PROPOSED CHANGE RTS-243A TO THE DUANE ARNOLD ENERGY CENTER
TECHNICAL SPECIFICATIONS

The holders of license DPR-49 for the Duane Arnold Energy Center propose to amend Appendix A (Technical Specifications) to said license by deleting certain current pages and replacing them with the attached, new pages. The List of Affected Pages is given below.

DAEC Emergency Service
Water Flow Requirement
Figure 4.8.E-1

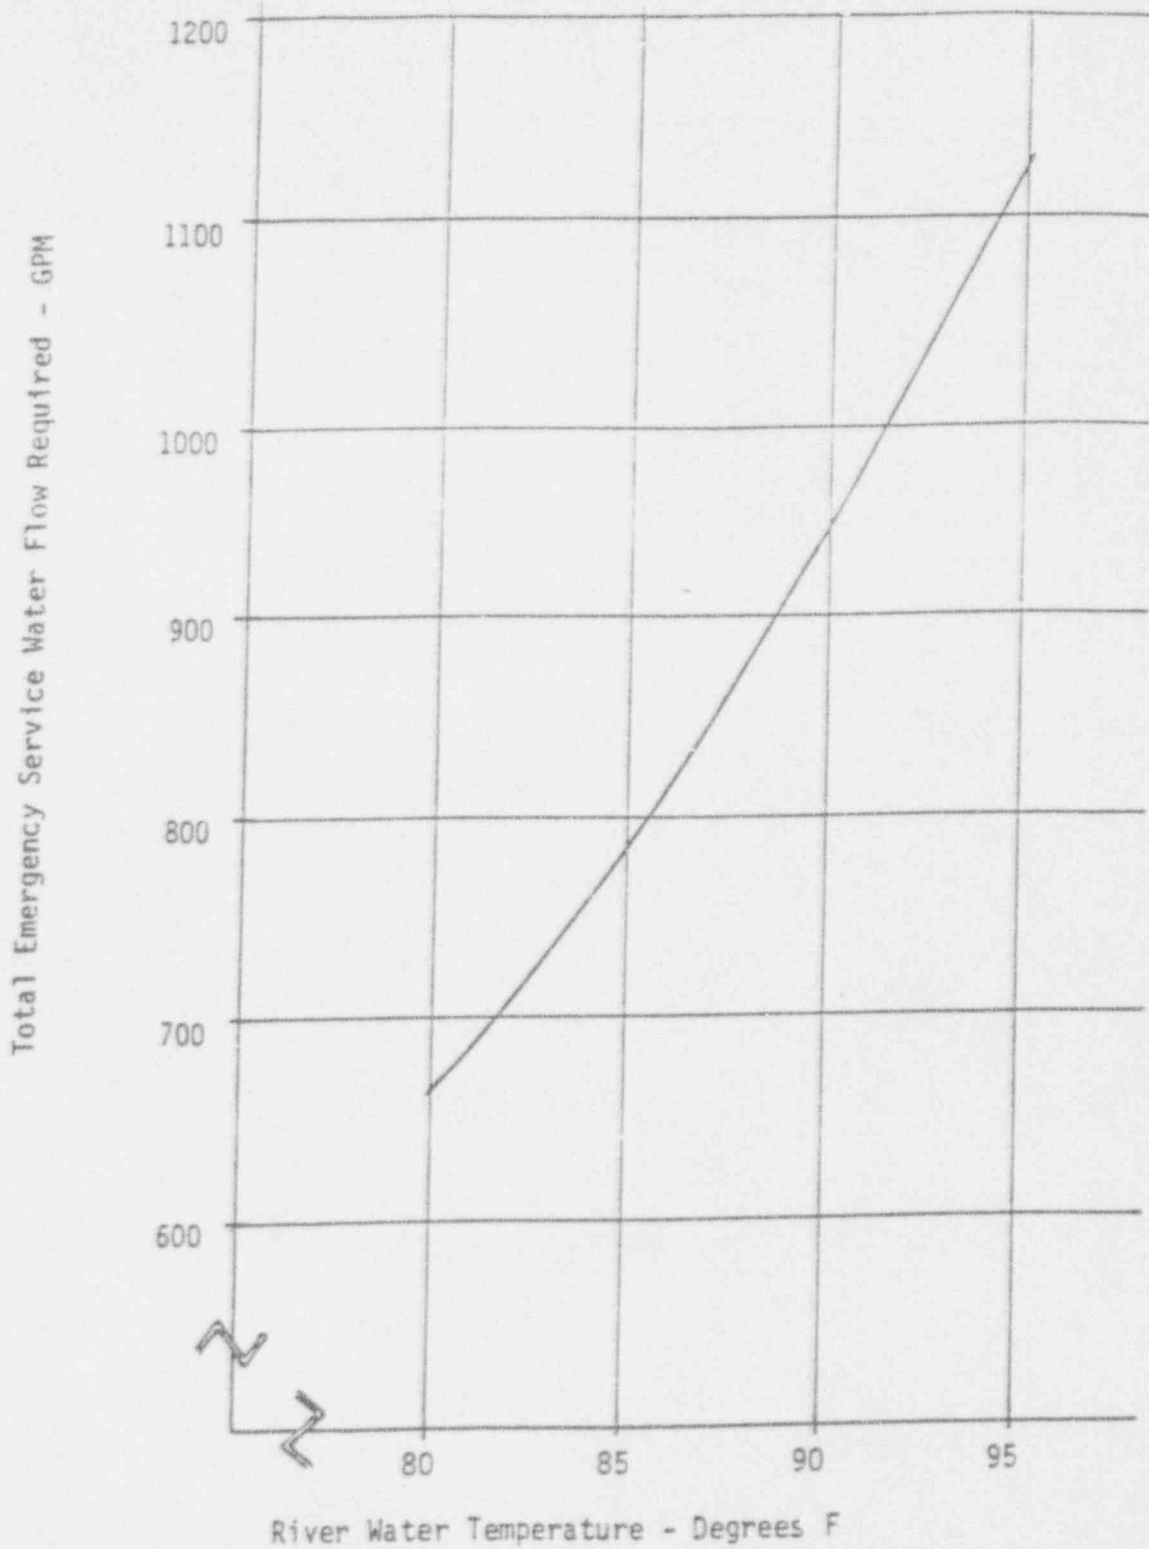
3.8-6a	<p>This page has been deleted.</p>
3.8-7	<p>The proposed Figure 4.8.E-1 (existing 4.8.C-1) has been renumbered consistent with the reorganization.</p>
